Proposal for :
Supplement 2 to the 04 series of amendments
(and Supplement 3 to the 03 series of amendments)
of UN Regulation No. 127 (Pedestrian safety)

Submitted by the experts from OICA*

The text reproduced below was prepared by the experts from OICA to amend document ECE/TRANS/WP.29/GRSP/2023/50, voted in June 2023 WP29, to clarify the definition of the “third of windscreen”.

Figure 17 – Third of the windscreen test area (example where P is the most outboard point)

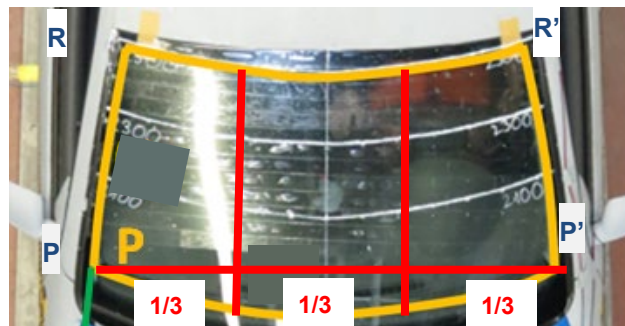
Amend paragraph 2.49., to read:

"2.49. "Third of the windscreen test area" means the geometric trace of the area between the lateral boundaries of the windscreen test area as defined in paragraph 2.44.(c), measured with a flexible tape following the outer contour of the windscreen ~~on any transverse section, divided in three equal parts.~~ **on the most outboard points P and P' (or rearward R and R' points) transverse section, divided in 3 equal parts, parallel to the longitudinal centreplane (see Figure 17)."**
